**RESPONSE TO ESSEX COUNTY COUNCIL'S COMMENTS ON THE PROPOSED DRAINAGE STRATEGY FOR THE PROPOSED DEVELOPMENT AT LAND WEST OF CLATTERBURY LANE, CLAVERING, ESSEX CB11 4QS**

This letter has been prepared in response to comments from Essex County Council LLFA to support the removal of the holding objection to planning application UTT/23/3113/PINS following on from the submission of an FRA prepared by EAS dated December 2023.

**Consultation Response – S62A/2023/0030 - Land to the west of Clatterbury Lane, Clavering, Essex**

OUTLINE APPLICATION	
BAYVA GROUP LTD.	
1st Floor, Millers House, Millers Road, Southend-on-Sea, Essex, SSO 8BA	
E.A.S.	
BAYVA GROUP LTD.	
CLAWING, ESSEX, CB11 4QS	
LAND TO THE WEST OF CLAWING LANE	
SUDS ATTENUATION STRATEGY	
DATE: 14/02/2024	SCALE: 1:1000
PROJECT NO: 4641/2023	SK05 - A

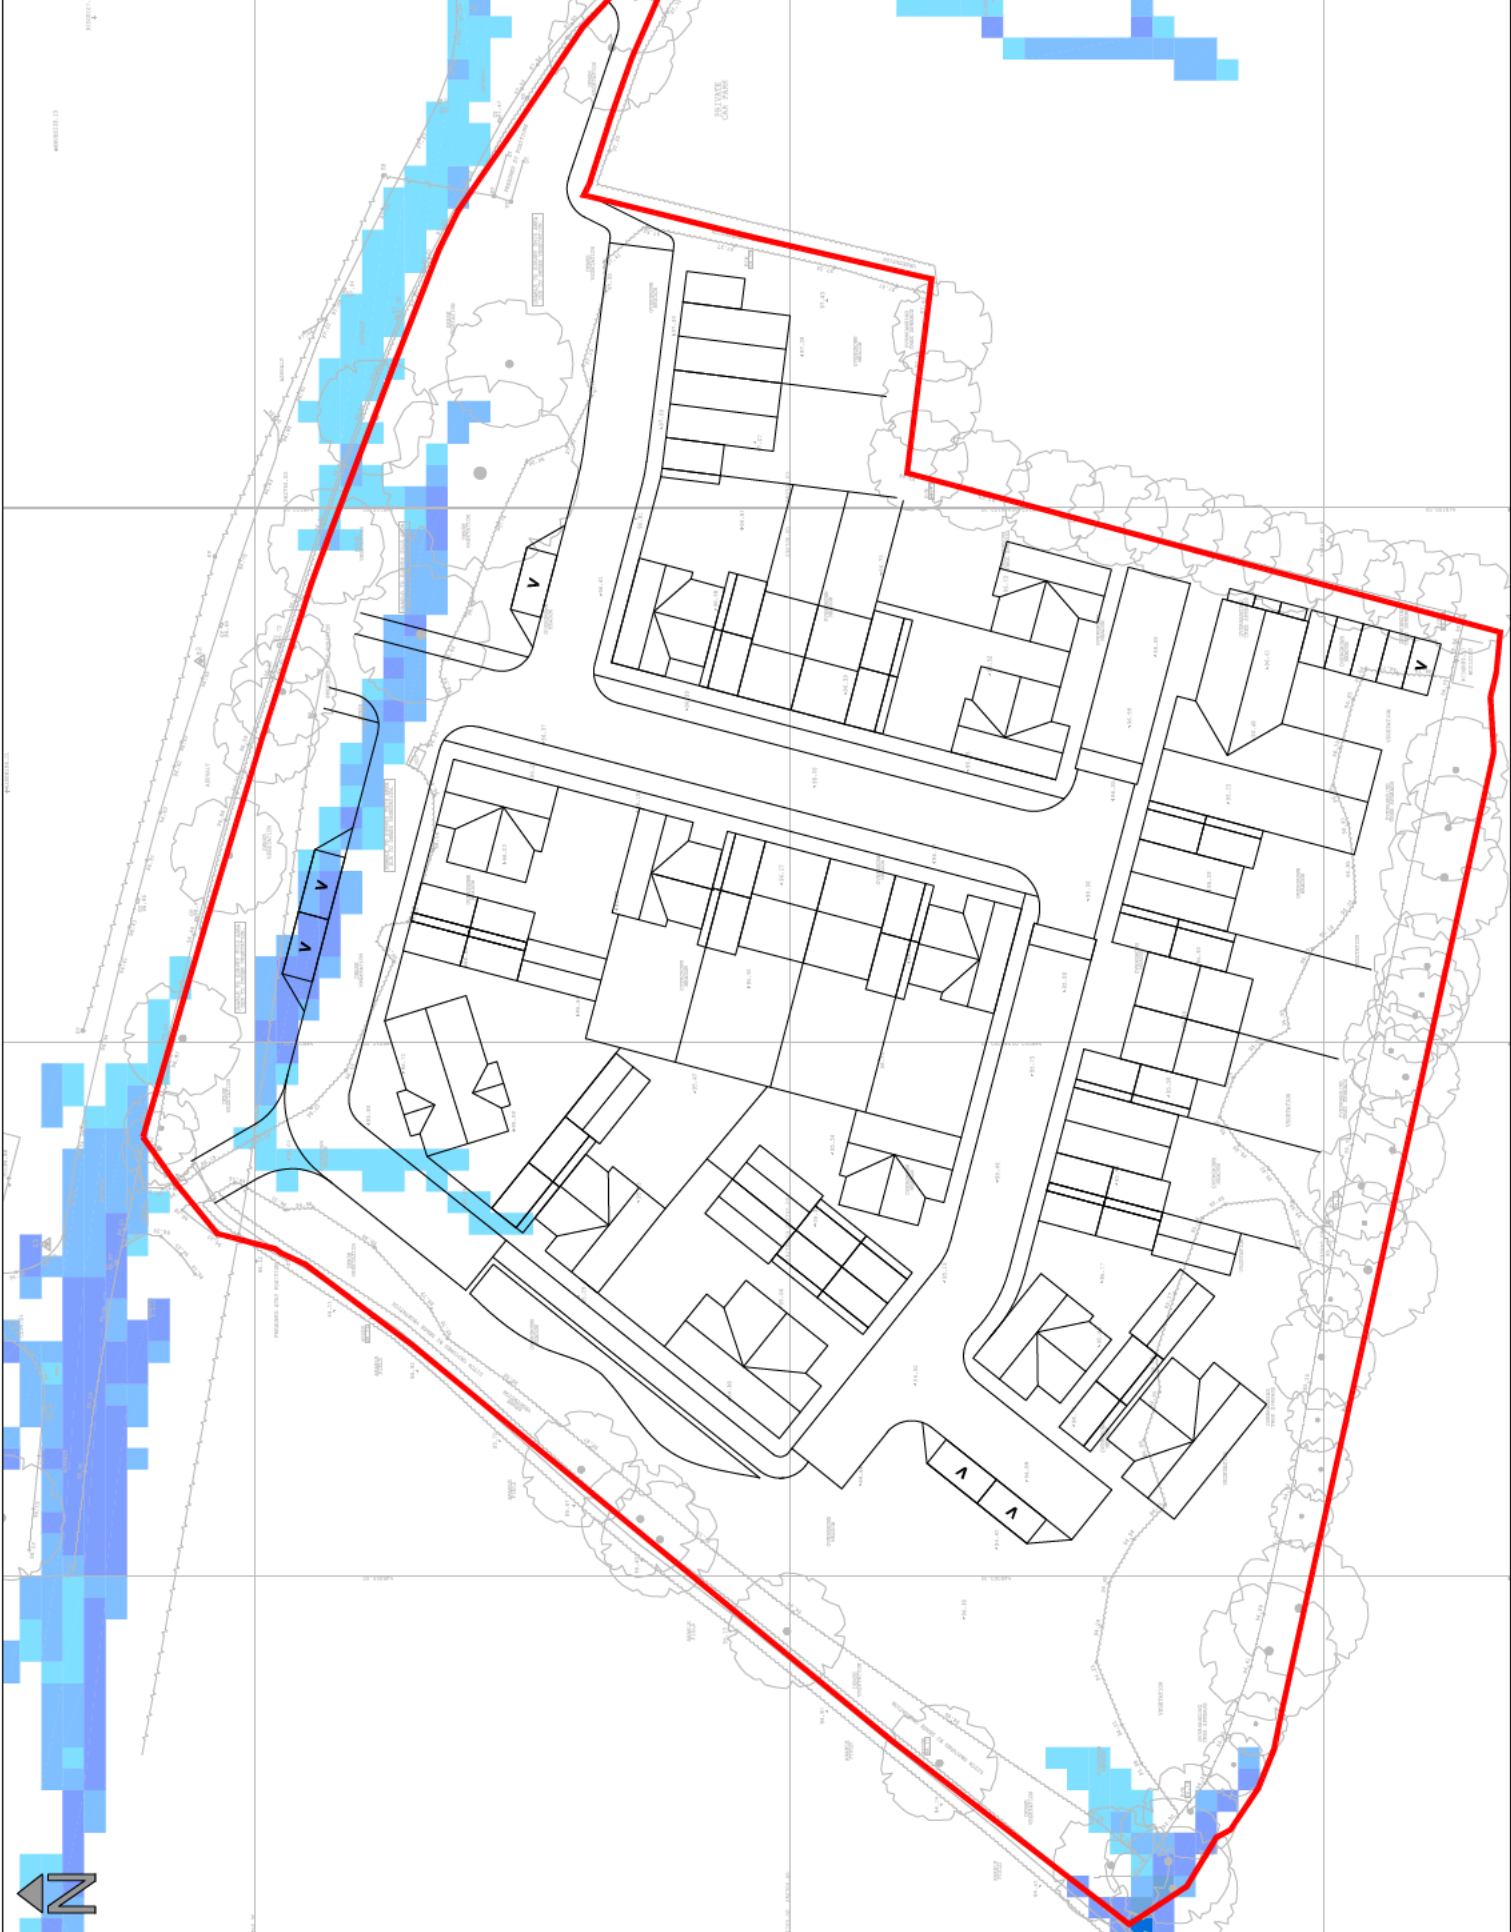
*"The LLFA require the discharge rate to be restricted to the 1 in 1-year greenfield runoff rate, and not the 1:2 year runoff rate as proposed for the alternative drainage strategy. Please note the LLFA do not accept the QBAR rate. This should be accompanied with the greenfield runoff rate estimation, as Appendix J currently appears blank."*

The proposed attenuation drainage strategy has been updated to restrict the maximum discharge rate from the site to match the 1 in 1 year rate of 2.3 l/s. This has resulted in the size of the proposed attenuation basin increasing slightly from 350m<sup>2</sup> to 367m<sup>2</sup>. The base area of the basin has also increased to 134.8m<sup>2</sup> however, the total depth of 1.2m including a 300mm freeboard has remained the same, with a permanently wet area with a depth of 600mm also still provided. The rest of the attenuation based drainage strategy has remained unchanged.

The Causeway Flow Calculations for the updated attenuation strategy have been included in **Appendix C** with the updated drainage plan included in **Appendix D**.

**1 IN 100 YEAR STORM FLOOD DEPTH LEVELS**

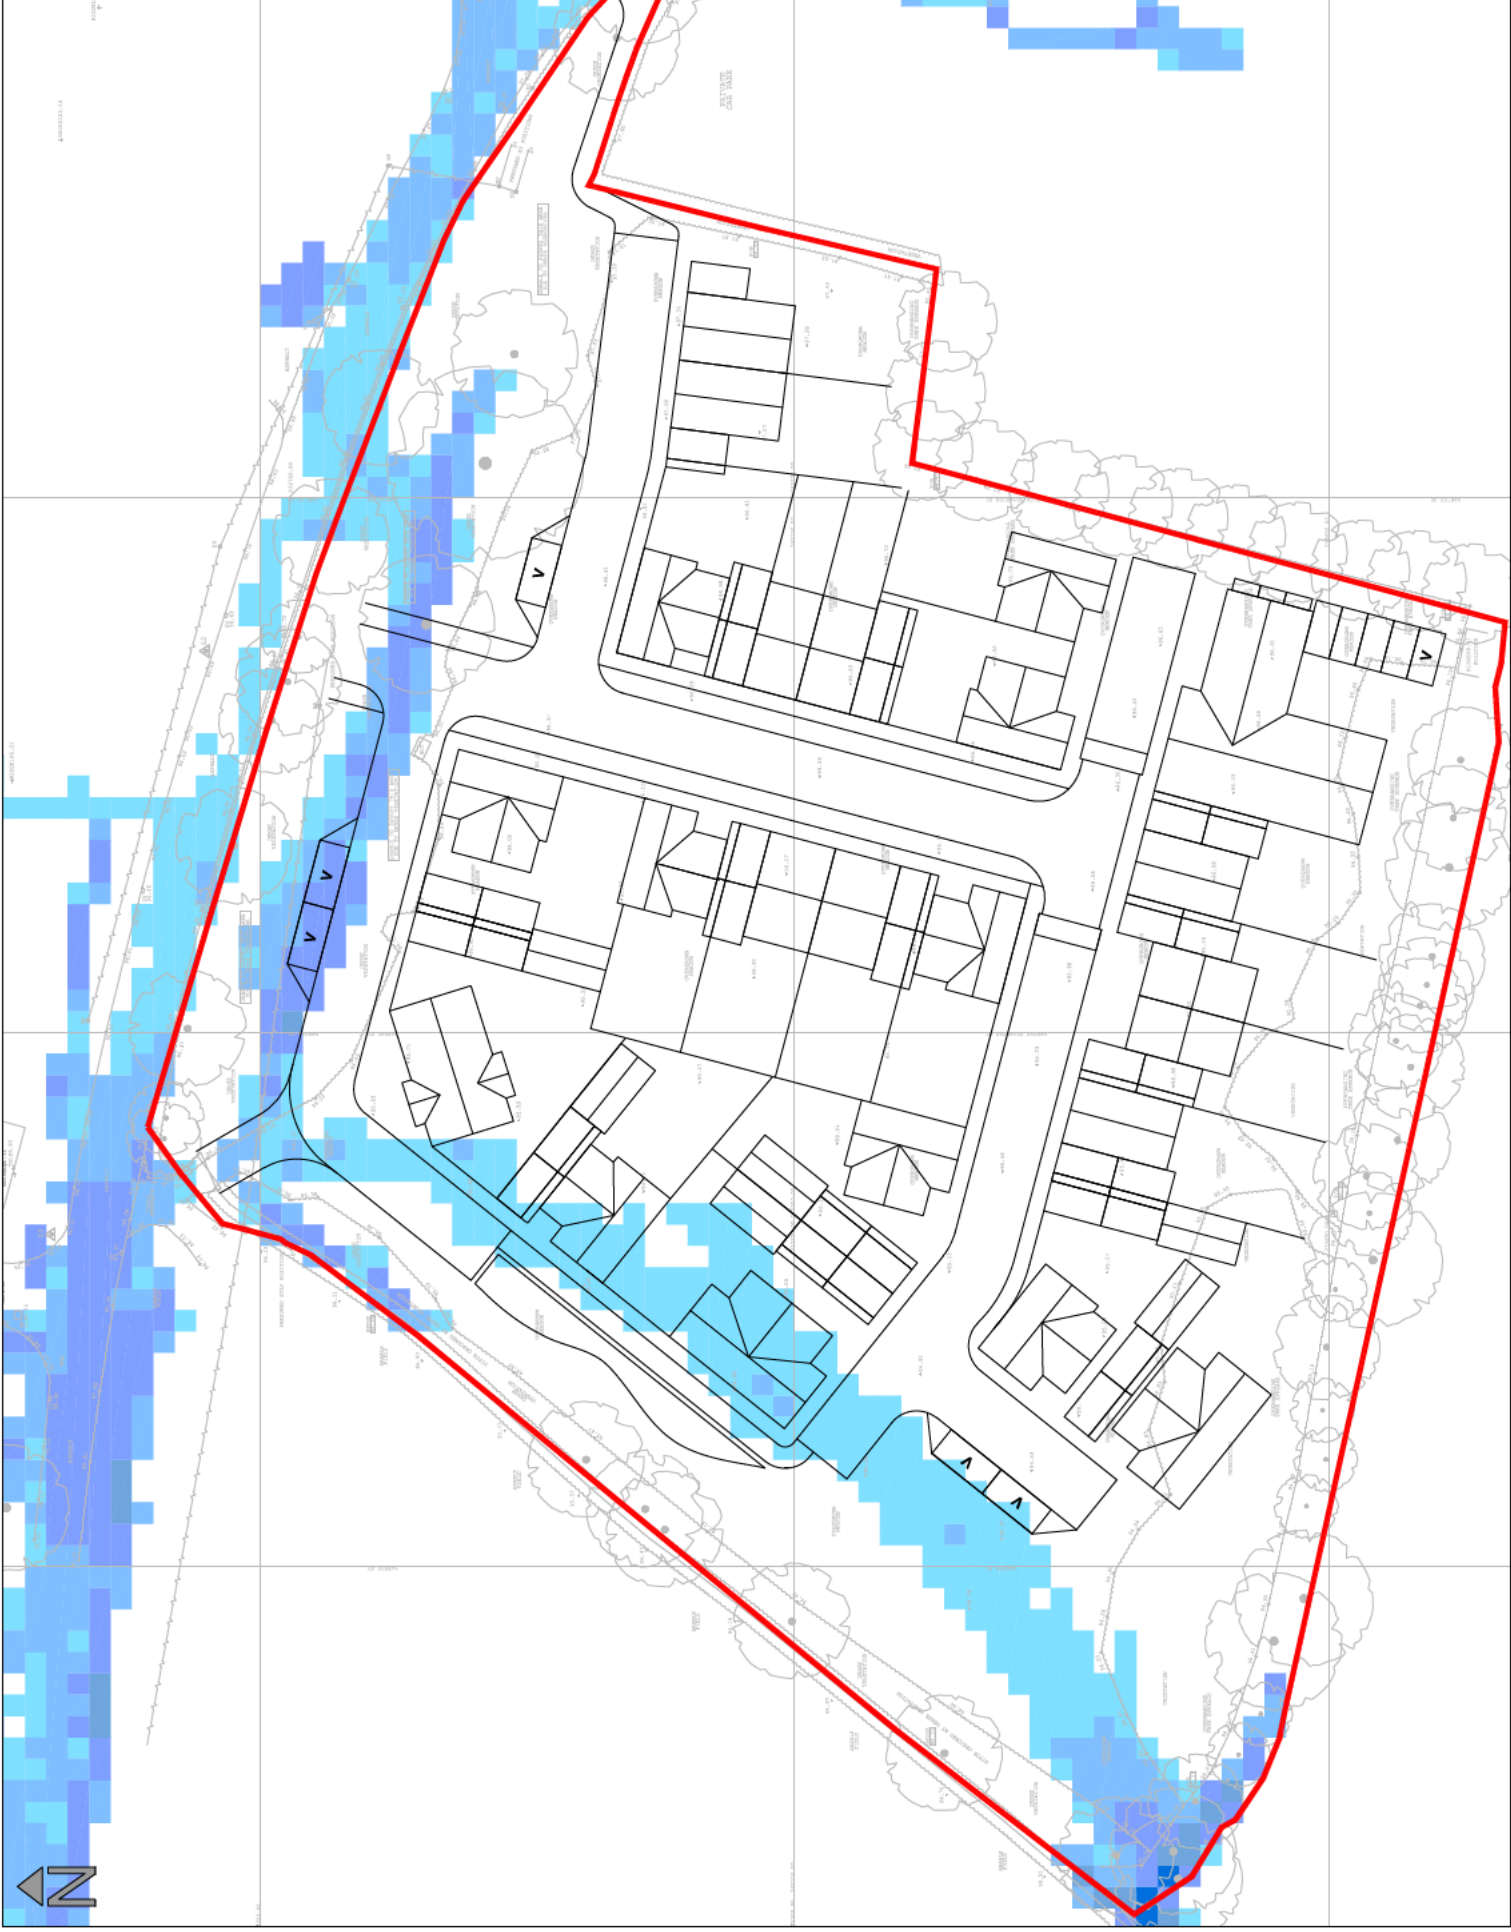
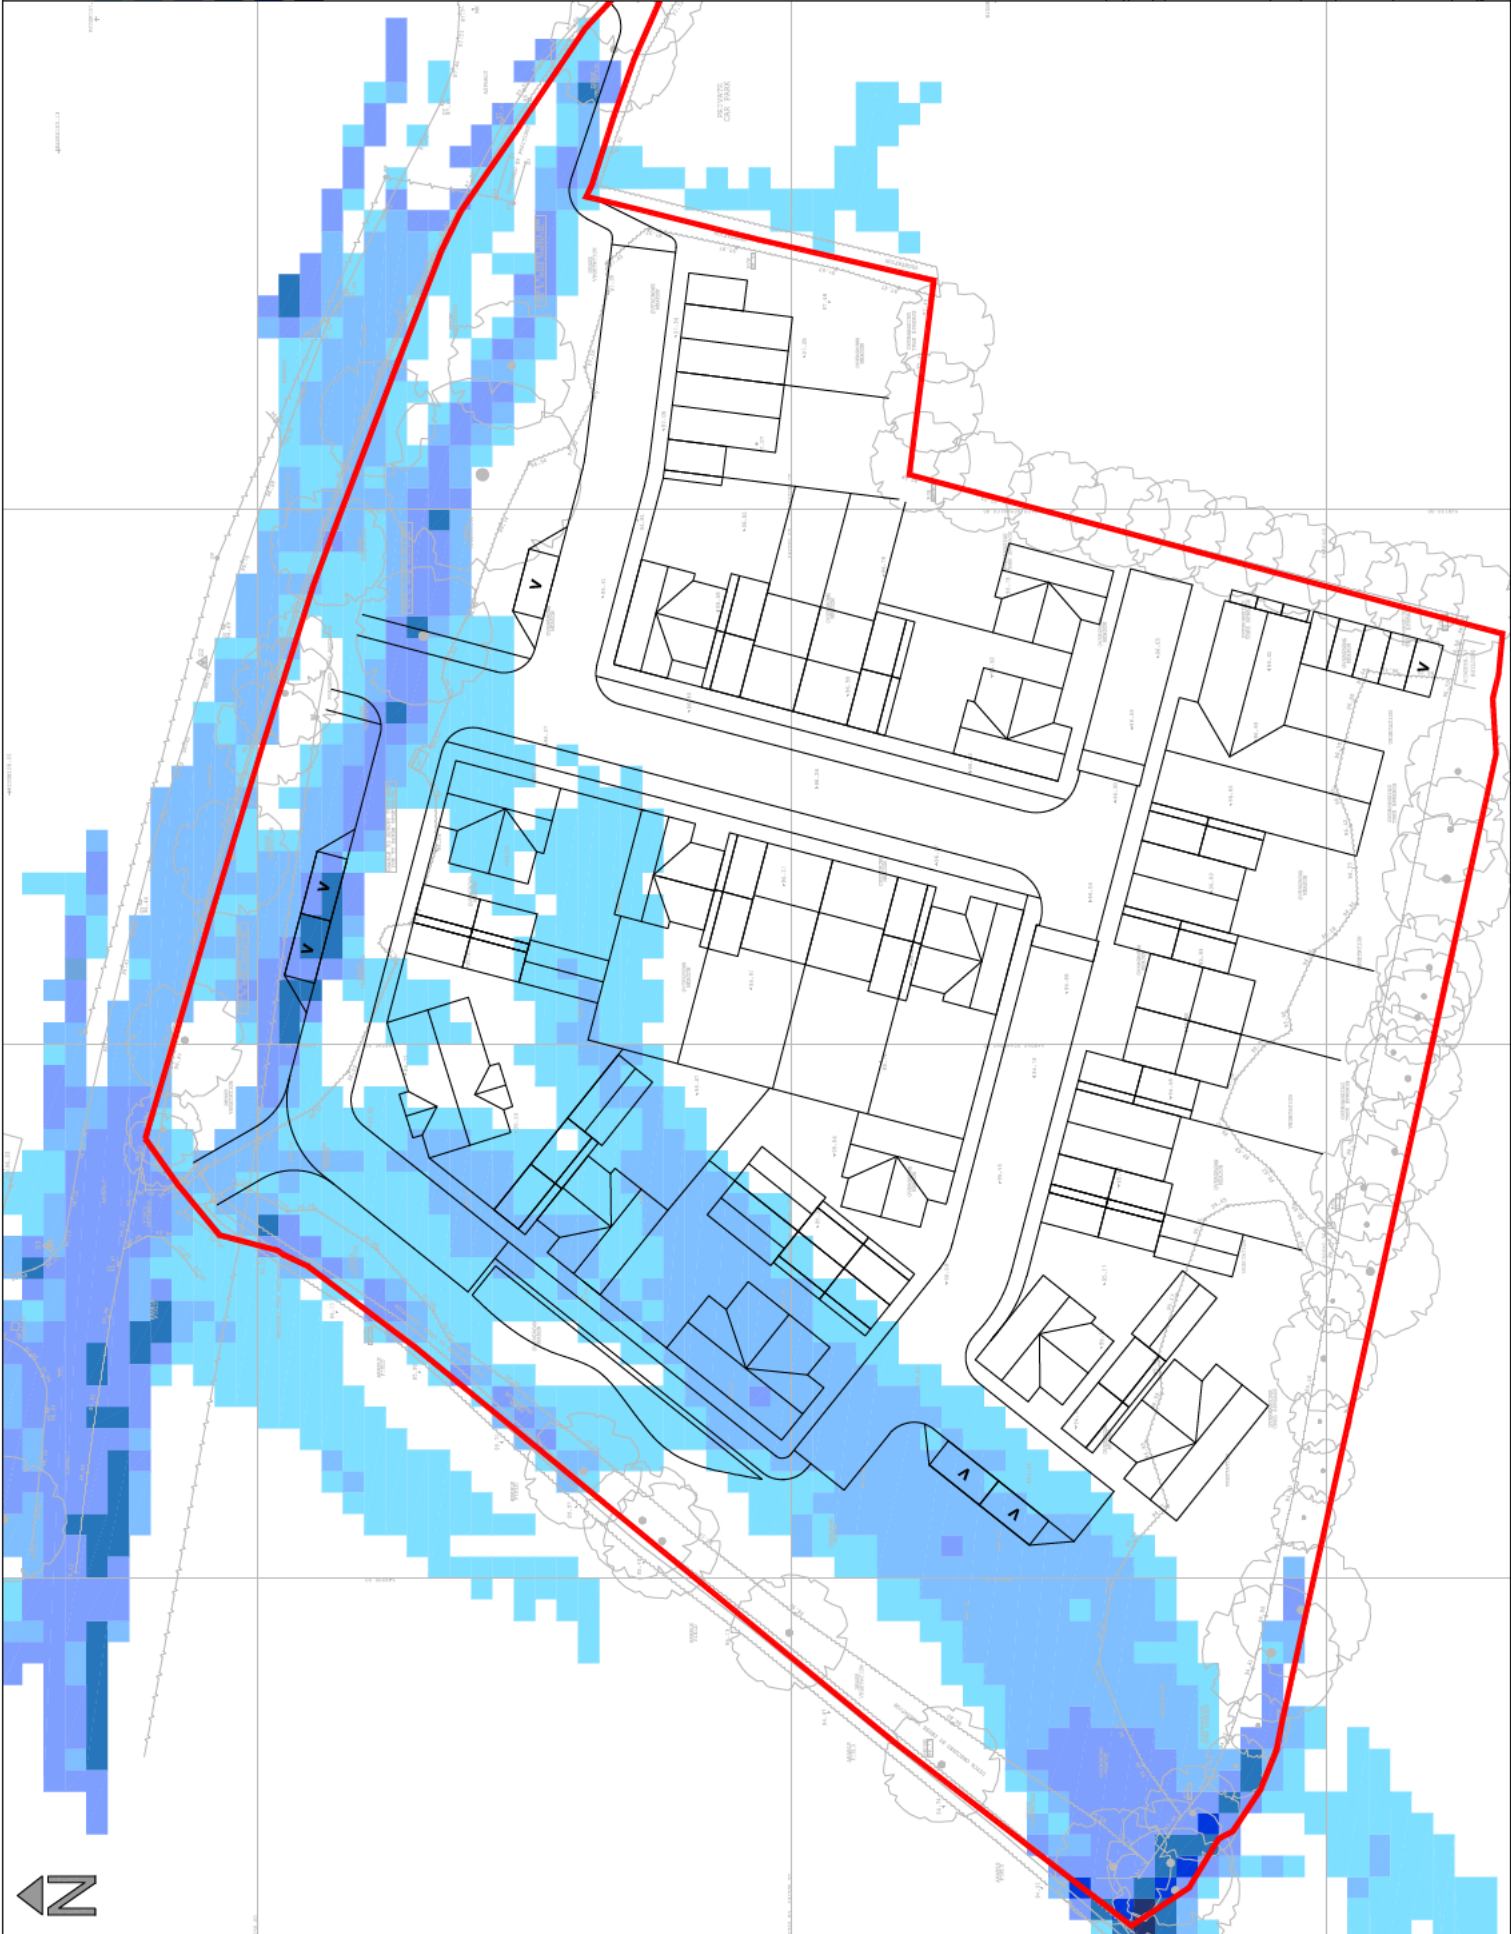
*"More information is required regarding the volume of onsite storage provided to mitigate against the offsite flows and whether the storage features have sufficient capacity to store any offsite flows."*

Due to surface water flood risk to the north of the development site it could be argued that offsite surface water flows could potentially enter the site. However, upon reviewing the detailed surface water flood risk data generated using QGIS included within the submitted FRA it can be seen that for both the 1 in 30yr and 1 in 100yr events the vast majority of flood depth to the immediate north of the site is shown to be below 150mm. Therefore, it is very likely that the majority if not all surface water flooding to the north of the site will be contained within the road before being directed west due to the gradient of the road, away from the site. Even during the 1 in 1000yr exceedance level event areas of flood depth to the north are shown to be less than 150mm however, during this event there are also areas shown to have a depth of up to 300mm with some small areas shown up to 600mm.

The surface water flood risk mapping has been included in **Appendix E** for reference.

Nonetheless, a 300mm freeboard has been provided within the proposed basin as part of both the attenuation and infiltration based drainage strategies. This freeboard provides a total storage volume of 99.7m<sup>3</sup> which would be available to store any offsite flows that do enter the site.
